MEMORANDUM**TO:** Montgomery County Planning Board**VIA:** Jeffrey Zyontz, Chief
County-wide Planning DivisionRichard C. Hawthorne, Chief
Transportation PlanningJudy Daniel, Team Leader
Community-Based Planning**FROM:** Larry Cole: 301-495-4528, for the Park and Planning Department**PROJECT:** Woodfield Road Extended
CIP Project No.500151**REVIEW TYPE:** Mandatory Referral No. MR# 01805-DPW&T-1**APPLICANT:** Montgomery County Department of
Public Works and Transportation**APPLYING FOR:** Plan Approval**COMMUNITY-BASED PLANNING TEAM AREA:** Rural

RECOMMENDATION: APPROVAL WITH COMMENTS TO DPWT

Typical Two-Lane Section

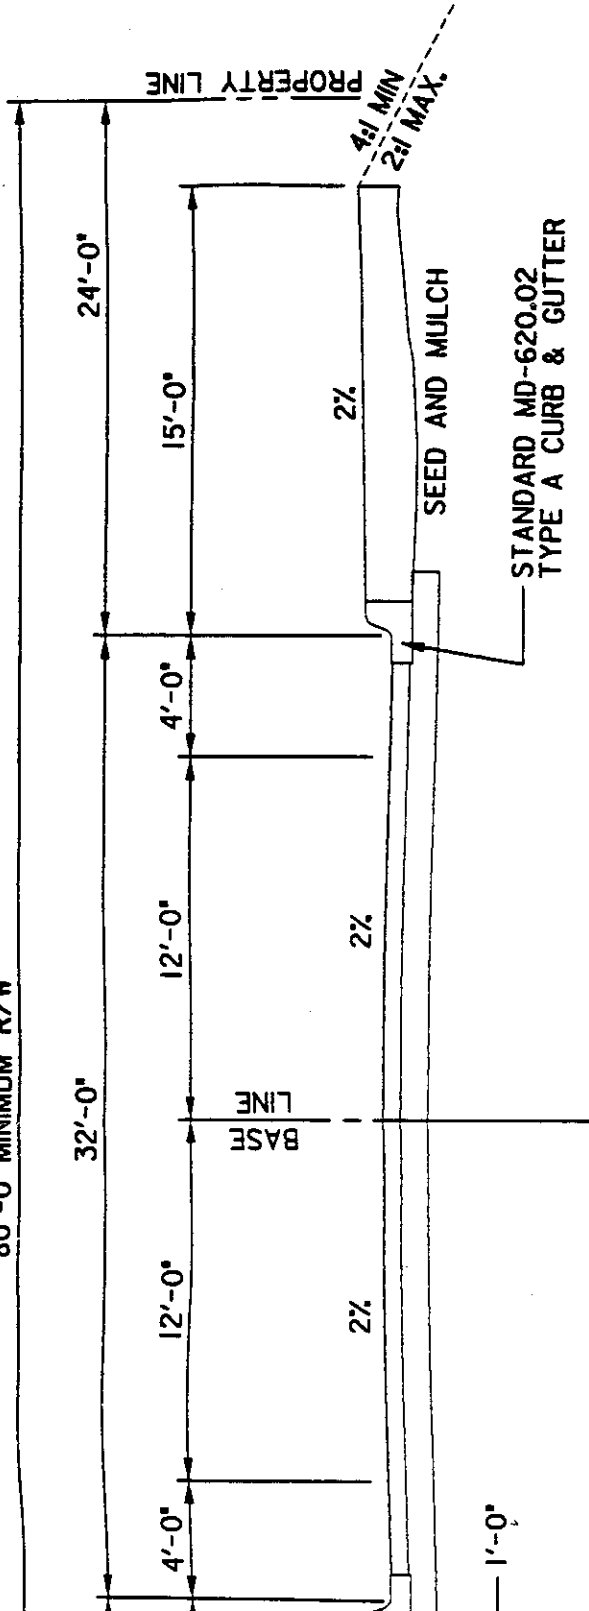
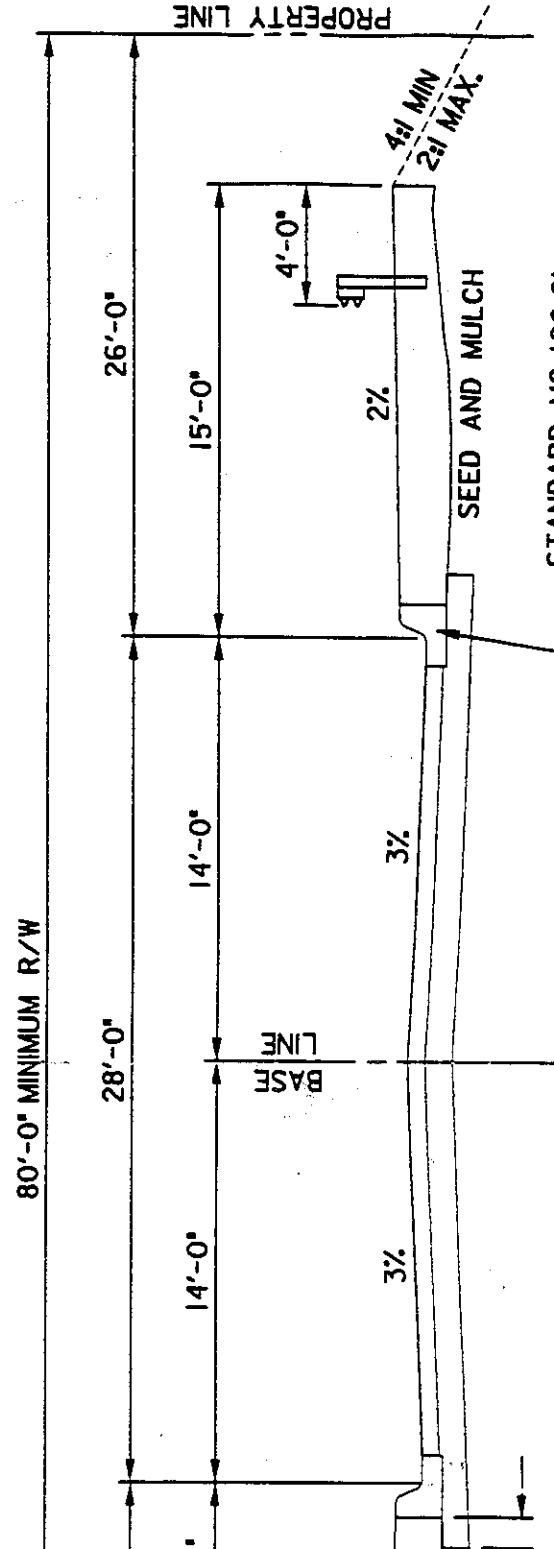
Twelve-foot travel lanes and four-foot shoulders would be provided in the reconstructed area of Ridge Road (see Attachment 4a). The proposed shoulders will provide a measure of safety for drivers and will accommodate on-road bicycle use.

While the posted speed of Ridge Road north of the intersection is anticipated to continue to be 40 mph, the proposed improvements to the alignment of the road may mean that the number of vehicles going faster than the speed limit may increase. *Staff recommends that the installation of a mountable curb be considered on Ridge Road north of the proposed intersection with Woodfield Road Extended.* South of the intersection, where the existing posted speed of 30 mph is anticipated to remain, there is not the same concern that vehicles will vault the curb.

The installation of curbs is proposed along this segment of Ridge Road, but normally where we have curbs, we also construct sidewalks and plant street trees. None are proposed in the current plans, however. *South of the proposed intersection, staff recommends that sidewalks be installed on both sides of Ridge Road. North of the intersection, headed toward the rural area, staff recommends that an off-road bike path be constructed on the east side of Ridge Road, a location that will tie well into the proposed bikeway on the north side of Woodfield Road Extended.*

Three-Lane Section at Northern End

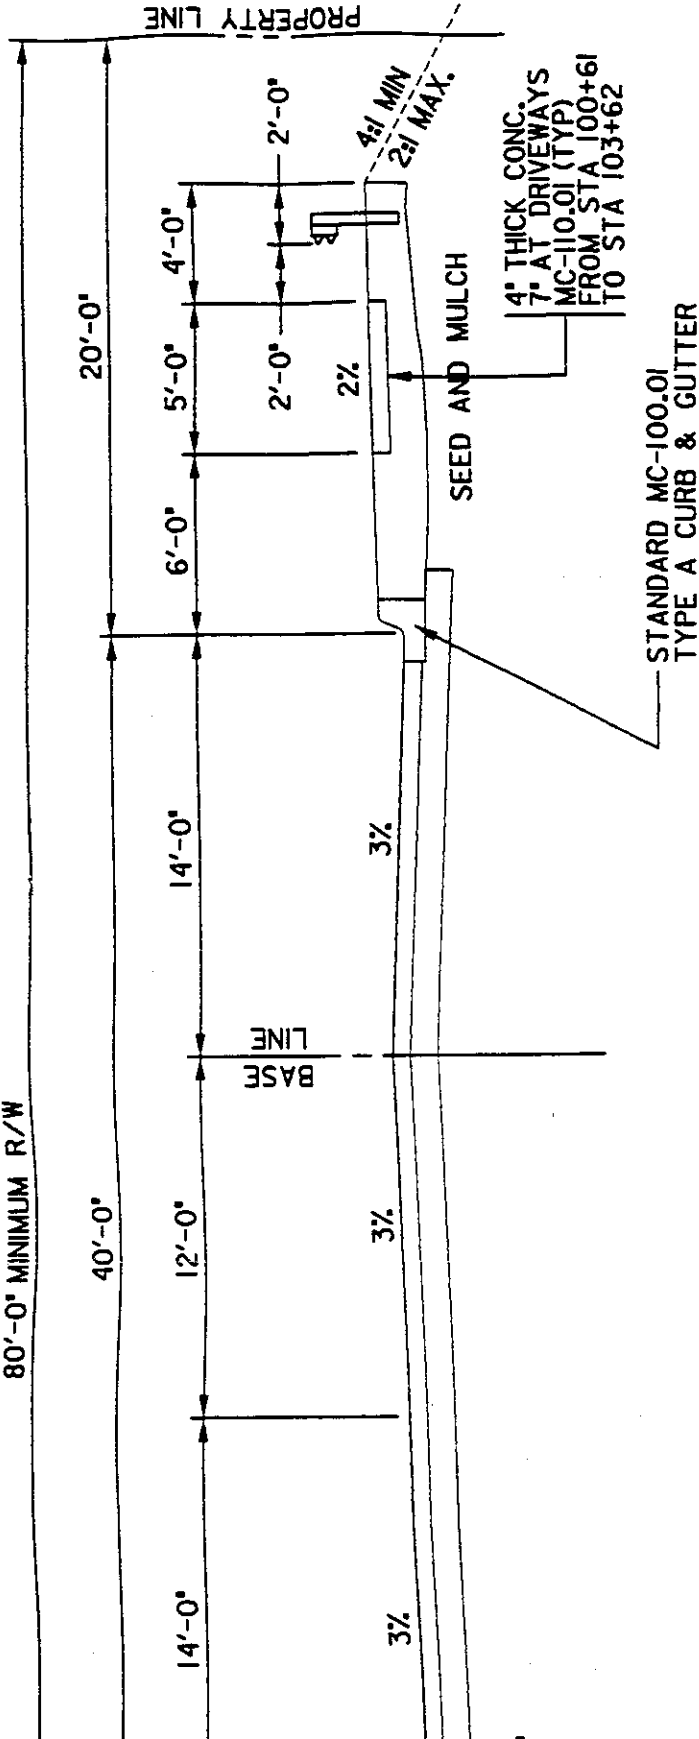
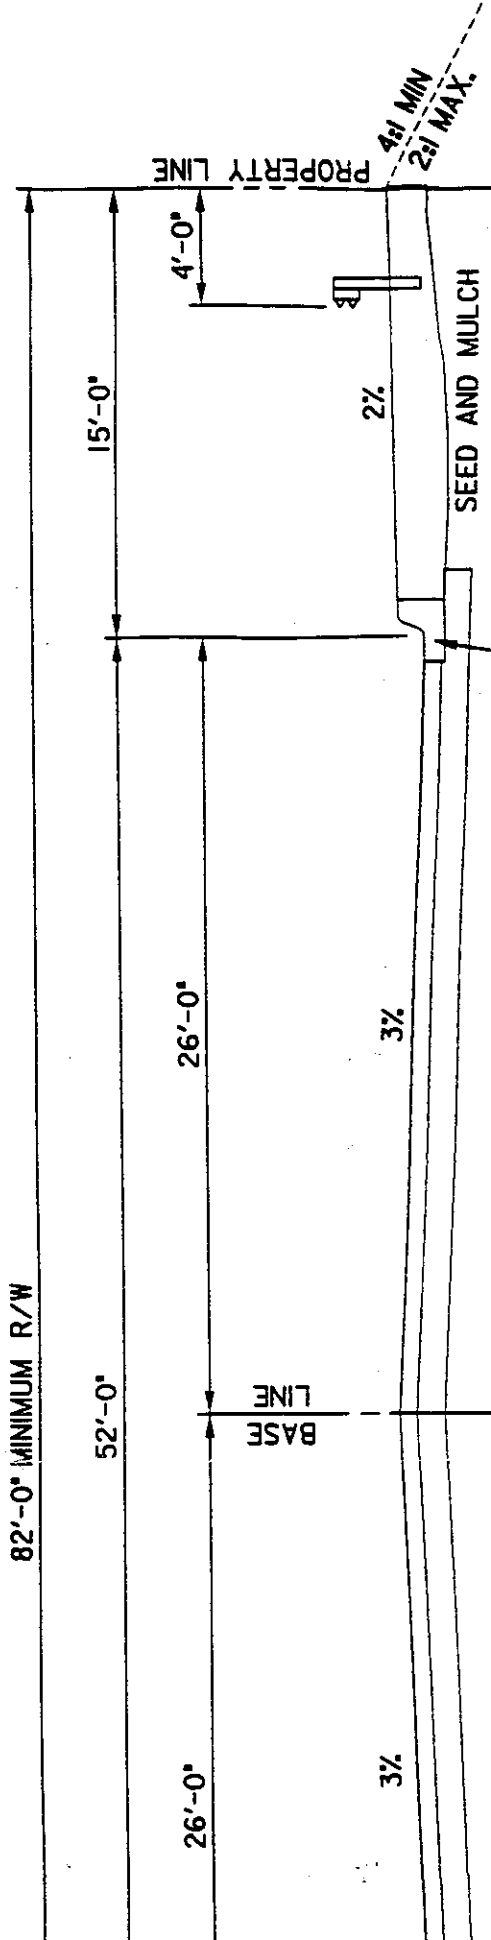
The County standard for a closed-section arterial road includes eight-foot landscape panels. The Project Prospectus also included eight-foot landscape panels, but the current design includes only six-foot landscape panels (see Attachment 4a). While six-foot panels are the County's minimum width to support the planting of street trees, eight feet would be better for the health of the trees and would provide a better offset for pedestrians and bicyclists on the sidewalk and bike path, particularly given that the previously planned on-road bike lanes, which would have provided greater separation of vehicles from pedestrians, will not now be built (see below). *Staff recommends that DPWT provide eight-foot landscape panels along Woodfield Road Extended where not constricted by wetlands or adjacent homes.*

Woodfield Road is classified as an arterial road with a two-to-five lane roadway section in an eighty-foot right-of-way. The Montgomery County standard for a closed-section arterial road has a fifty-foot curb-to-curb width. The proposed project would build the roadway as a two-lane closed section road (with curbs) for most of its length, with a curb-to-curb width of twenty-eight feet, far less than the standard but adequate to handle the projected traffic (see Attachment 4a). The northern end at Ridge Road would have a three-lane section (two travel lanes plus a left-turn lane) and the southern end would have a four-lane section, tying into the existing four-lane section at the post office (see Attachment 4b).

Details of Possible Alignments for A-12 at Ridge Road

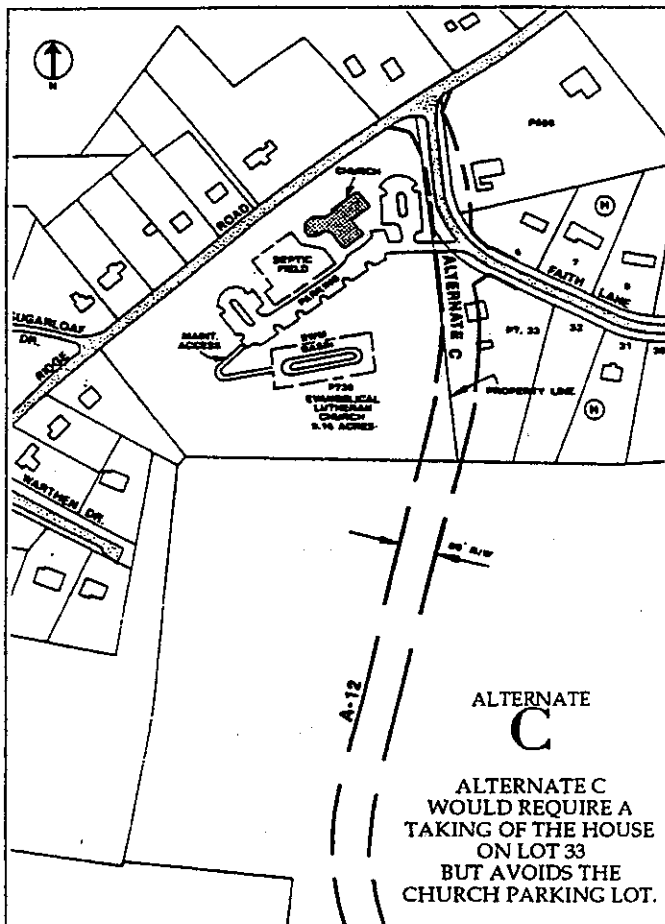
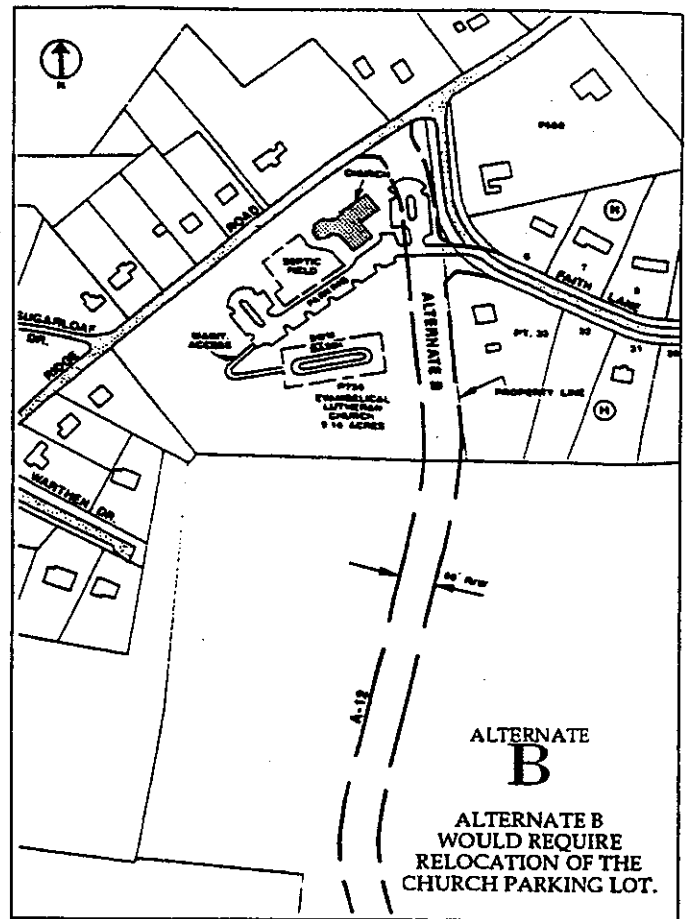
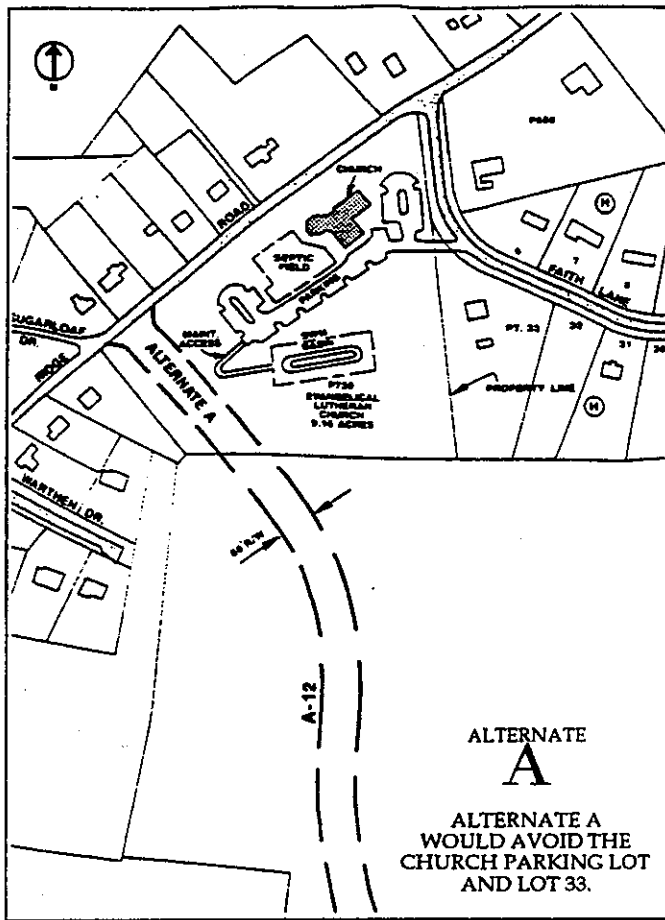
The Damascus Master Plan recommends that Woodfield Road be constructed as a two- to five-lane facility from its present terminus near the post office to intersect with Ridge Road. During the development of the February 1993 Amendment to the Master Plan work, three alternatives were considered, shown as Attachment 5. As the Amendment text notes, Alternate A was recommended; however, during the facility

planning of this project, an alignment more closely following a combination of Alternates B and C was found to be more feasible.
